AGENDA AND SCHEDULE FOR MIDLAND SUBCOMMITTEE MEETING, FEBRUARY 4, 1969

EXCERPT FROM SUMMARY OF 103RD ACRS MEETINGOCTOBER 31 - NOVEMBER 2, 1968MEETINGS WITH THE DIRECTOR OF REGULATION AND THE REGULATORY STAFF10. Dow Midland Plant

EXCERPT FROM SUMMARY OF 106TH ACRS MEETING

D. Midland 1: Containment Liner Problem

MIDLAND PLANT UNITS 1 & 2 CONSUMERS POWER COMPANY		
REACTOR BUILDING TYPICAL DETAILS		
7220	FIG. No 5-1	A

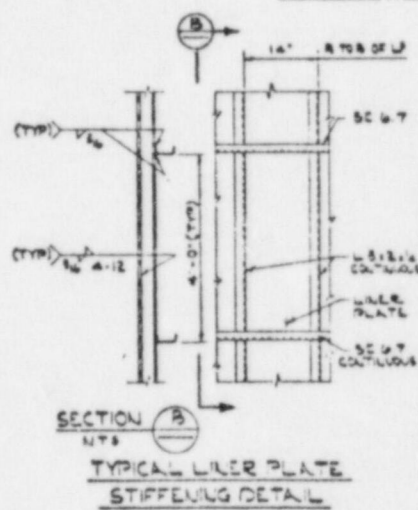
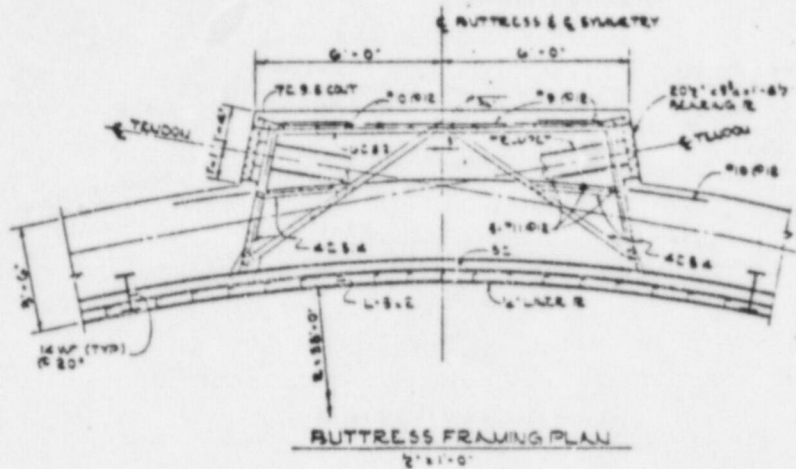
Bulge in Portinera + Liner.

See Note #1
and #2

See Note #1
--and #3--

Max. Deflec
~ 3'-0"

K. Seyfrit, NRC Staff, discussed a recently occurring problem at the Midland Plant, Unit 1, where a bulge developed in the containment liner. This plant is currently still in the construction stage. (For details of the bulge, see Appendix XXVIII.) He stated that the cause of the problem is believed to have been a leak in a water line used to cool the containment concrete during curing. Had the curing process been completed, this water line would have been grouted. He noted that this is a preliminary report, and that details will be reported at a later date.

K. Seyfrit stated that the Applicant has cut sections of the bulge away to clear debris. The method to be used to repair the liner has not yet been determined. The Applicant has not yet analyzed the pressure which caused the bulge to see whether or not it was adequate to fail the liner welds.
